Access Compliance Report

Public Rights-of-Way

Intersection ID: 11839	Main Street: FLEETWOOD_DR	Cross Street: EVERGREEN_DR	Location: SE
ADA ID: 0AFEAD039EAA	Ramp Type: Perp	Initial Pass/Fail: Fail	Overall Compliance: No
			Severity Score: 21.25

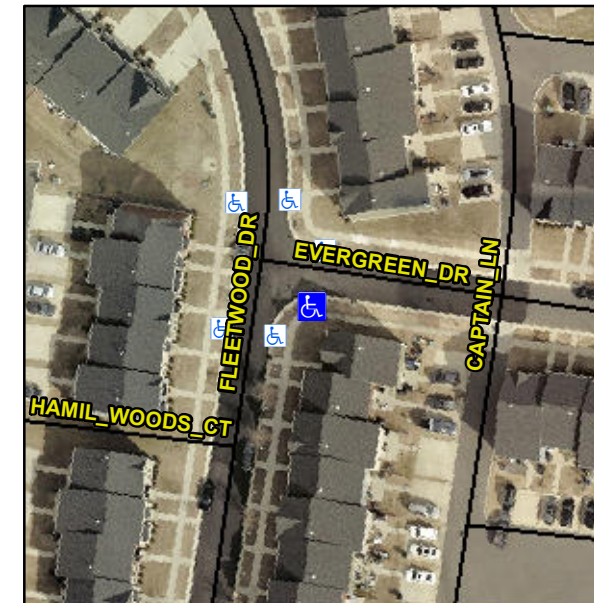
Not Found, R304.5.1, R304.2.2

Compliance	Description	Data	Compliance	Description	Data
N/A	Ramp Length (in)	73.0	No	Ramp Slope (%)	10.1
No	Ramp Width (in)	47.0	Yes	Ramp XSlope (%)	0.6
N/A	Flare Type LT	N/A	N/A	Flare Type RT	N/A
N/A	Flare Slope LT (%)	N/A	N/A	Flare Slope RT (%)	N/A
N/A	Flare Traversable LT?	N/A	N/A	Flare Traversable RT?	N/A
N/A	Landing Length (in)	N/A	N/A	DWS Provided?	N/A
N/A	Landing Width (in)	N/A	N/A	DWS Contrast?	N/A
N/A	Landing Slope (%)	N/A	N/A	DWS Length (in)	N/A
N/A	Landing X Slope (%)	N/A	N/A	DWS Full Width?	N/A
N/A	Landing Curb? (Y/N)	N/A	N/A	DWS Offset (in)	N/A
N/A	Shared Landing?	N/A			
N/A	Gutter Ponding?	N/A	N/A	Gutter Slope (%)	N/A
N/A	Gutter Lip Ht (in)	N/A	N/A	Gutter X Slope (%)	N/A
N/A	Painted X Walk1?	No	N/A	Painted X Walk2?	N/A
	X Walk 1 Direction	To N		X Walk 2 Direction	N/A
N/A	X Walk 1 Width (in)	N/A	N/A	X Walk 2 Width (in)	N/A
	X Walk 1 Slope (%)	2.5		X Walk 2 Slope (%)	N/A
	X Walk 1 X Slope (%)	1.9		X Walk 2 X Slope (%)	N/A

Remove & Replace Entire Ramp.
